Whirl Wind Propellers

SERVICE LETTER

SL-GA-J2B-012714

TO: ALL OWNERS / OPERATORS OF AFFECTED PROPELLERS
SUBJECT: BLADE CLAMP BOLT CRACK
DATE: JANUARY 27, 2014

FIGURE 1 (SL-GA-J2B-012714)

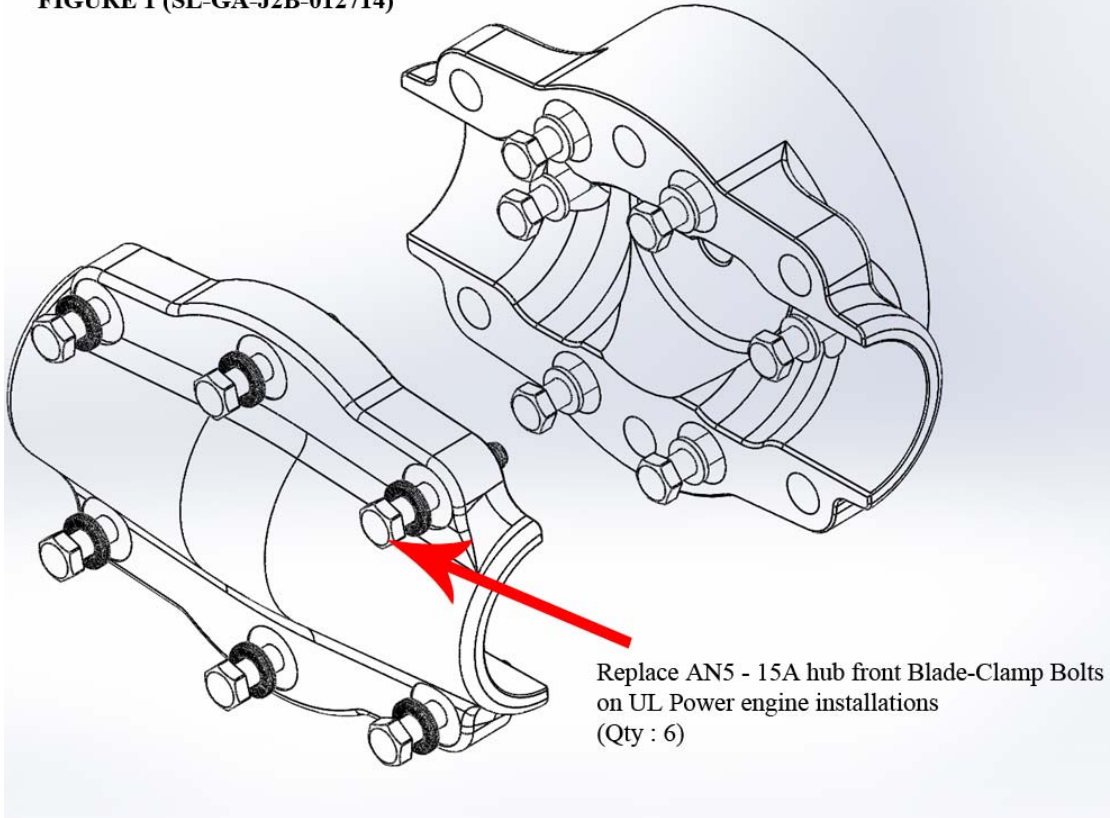
REASON: Upon routine inspection of a **GA-J2B** propeller in the affected Serial Number range, installed on a UL350is engine, one of the propeller hub blade-clamp bolts (AN5-15A) was found to have a crack. The propeller was installed on a UL-350is engine, with 65" diameter blades. The propeller had 300+ hours total time. The bolt crack found so far has been an isolated case.

ACTION: *Reference Figure 1 on Page 2*

Recommend replacement of all 6 front hub blade-clamp bolts (AN5-15A) at time of every Annual or every 100 hrs, whichever occurs first.

Mandatory replacement of all 6 front hub blade-clamp bolts (AN5-15A) before next flight.
